Subject: Final Environmental Assessment (FEA) and Finding of No Significant Impact (FONSI), Kawai Nui Model Airplane Park Comfort Station TMK: 1<sup>st</sup> 4-2-16:1, Kapaa Quarry Road, Kailua, Oahu, Hawaii

# KAWAI NUI MODEL AIRPLANE PARK

## COMFORT STATION

### FINAL ENVIRONMENTAL ASSESSMENT

Figure  
**6**

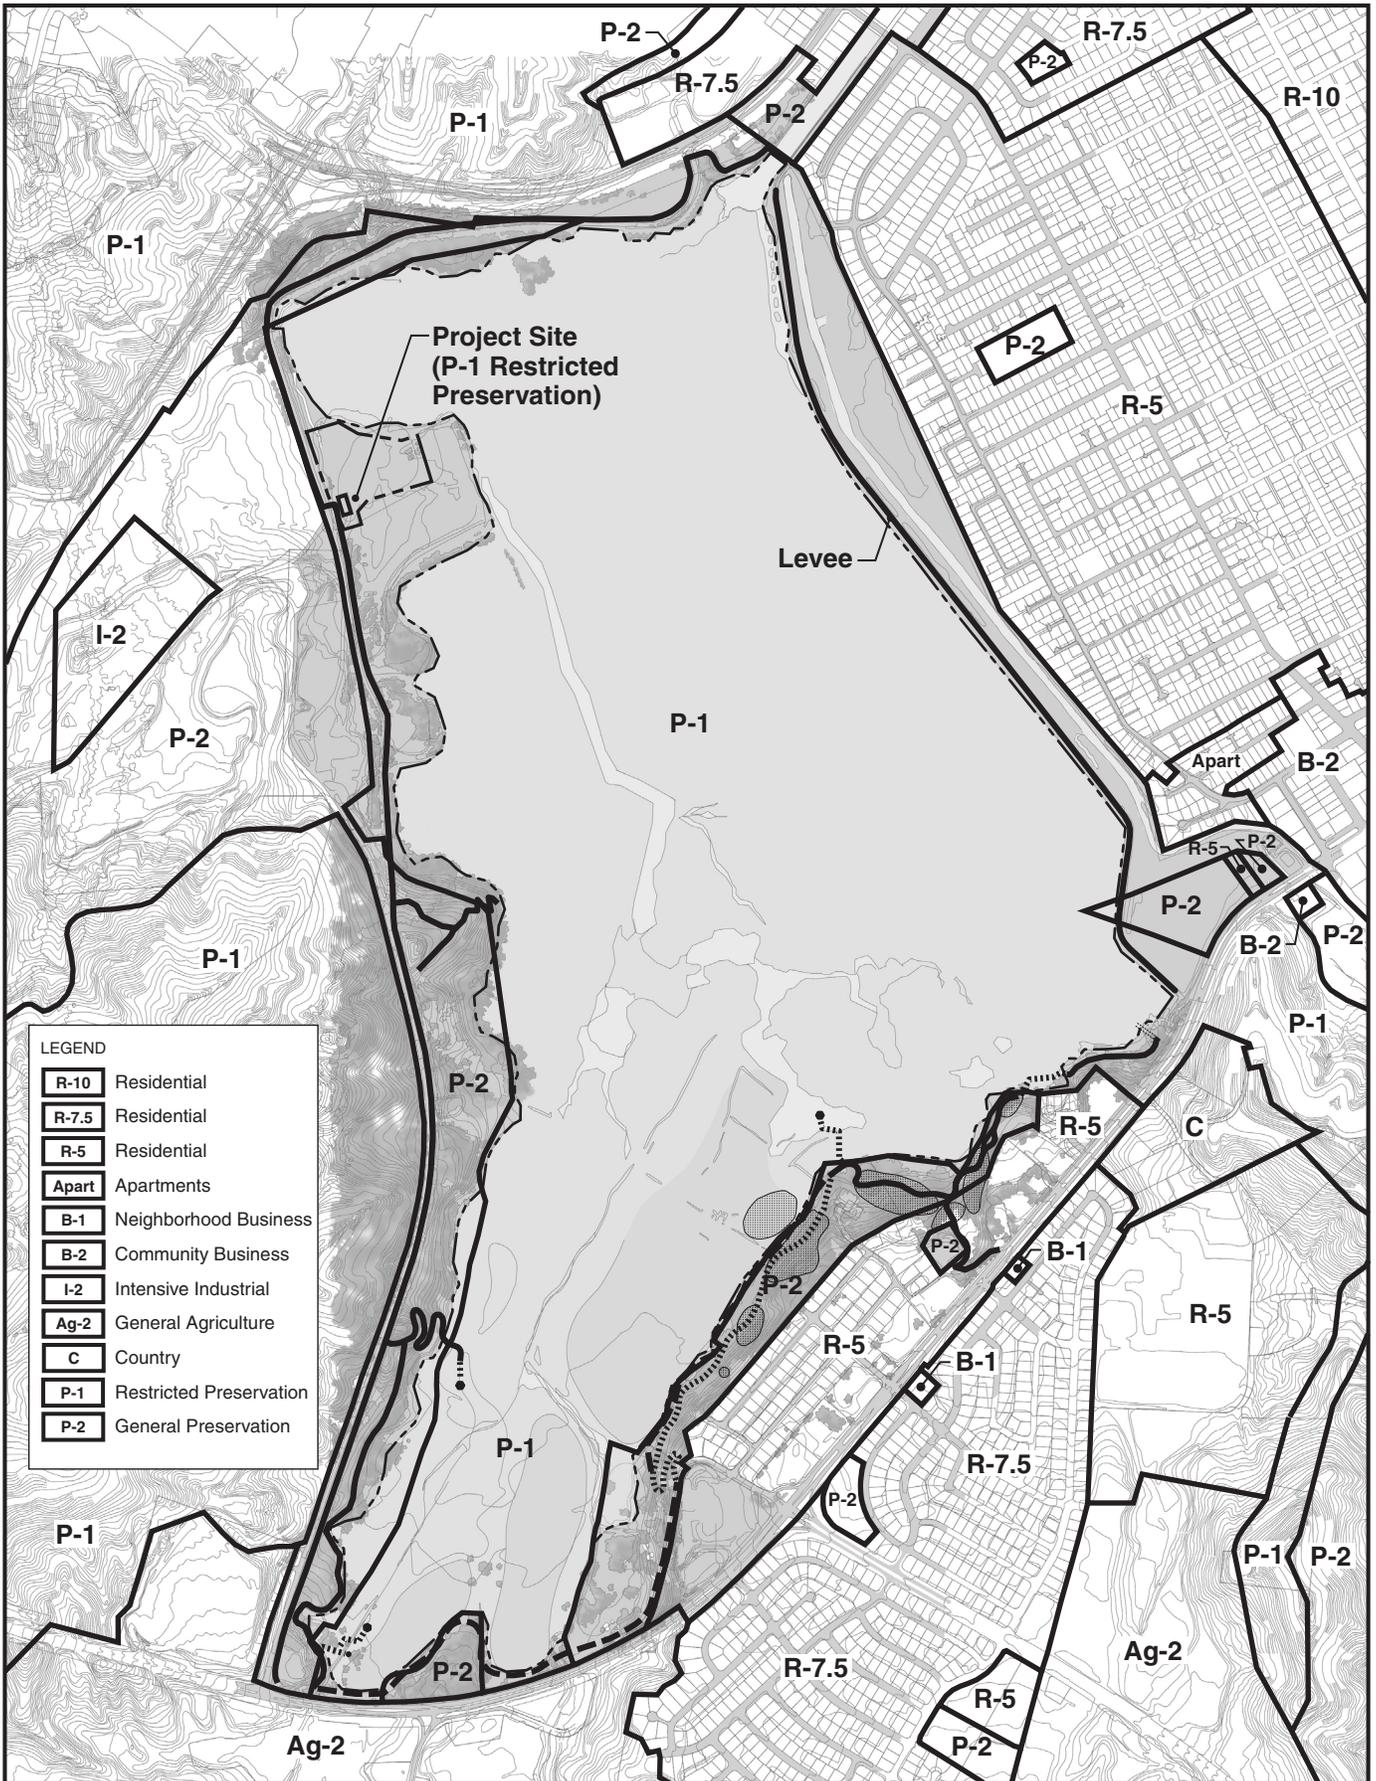
3. Section 2.2 (Project Background, Consistency with Community Directions): In Line 8, please change "Kauai" to "Kawai."
  4. Figure 6 (Zoning Map): Our records indicate that the project site is located within the P-1 Restricted Preservation District. Figure 6, however, gives the impression that the site is within the P-2 General Preservation District. Please confirm that the project site is located within the P-1 District and amend Figure 6 to show the proper zoning designation for the site.

**Figure 6 (Zoning Map):** Your comment stated: "Our records indicate that the project site is located within the P-1 Restricted Preservation District. Figure 6, however, gives the impression that the site is within the P-2 General Preservation District. Please confirm that the project site is located within the P-1 District and amend Figure 6 to show the proper zoning designation for the site."

The project site is located within the P-1 Restricted Preservation District, and the proper zoning designation is shown on Figure 6. We apologize that the line weights and shading on the graphic were confusing. We revised the graphic to add a call-out indicating "Project Site (P-1)" to avoid possible confusion regarding the zoning designation of the site.
